CITY OF ALBUQUERQUE

RE: **Volcano Cliffs Subdivision Lot 18, Block 4, Unit 19**
6535 Vista Del Prado Dr. NW
Grading and Drainage Plan
Engineers Stamp Date 5/19/17 (D10D003T18)

James D. Hughes, P.E.
Principal Engineer, Hydrology
Planning Department

GRADING AND DRAINAGE PLAN

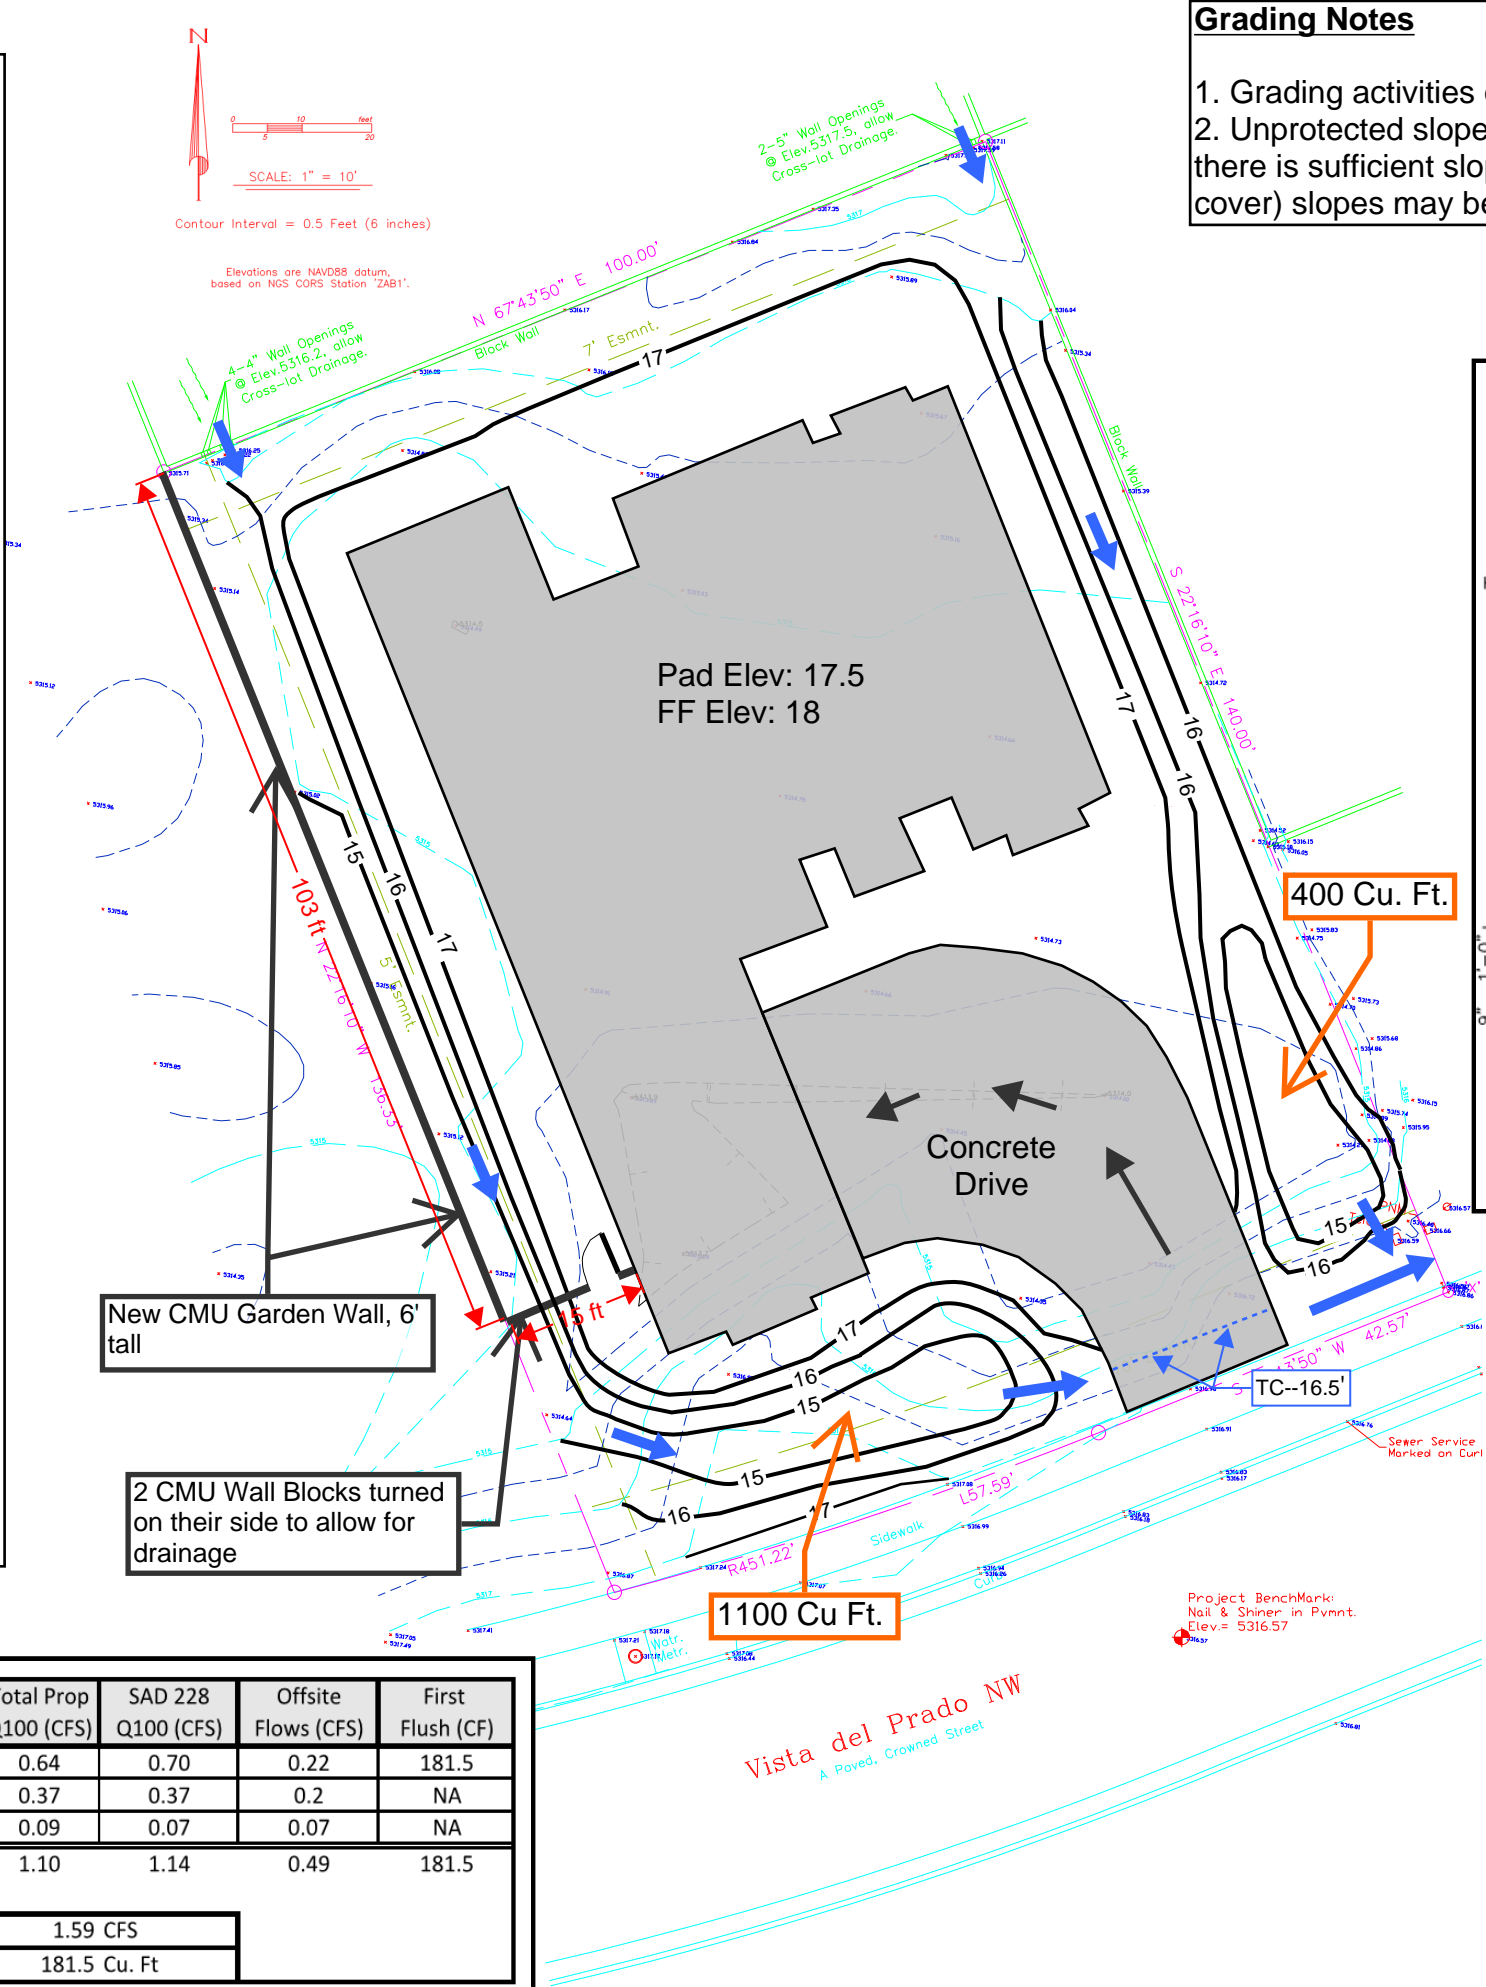
Based upon the information provided in your submittal received 5/24/17, this plan is approved for Grading Permit. Building permit will not be issued until Pad Certification is accepted.

Please attach a copy of this approved plan to the construction sets in the permitting process prior to sign-off by Hydrology. Also, please advise the owner/contractor that a separate wall permit must be obtained and this approved grading plan dated 5/24/17 must be provided with the wall permit application. Also, please advise the contractor/owner that the ponds must stay in place or CO will not be granted.

A pad certification is required before concrete is poured, either by a letter from you stating that the pad is built according to the plan submitted or by an as-built with elevations plotted.
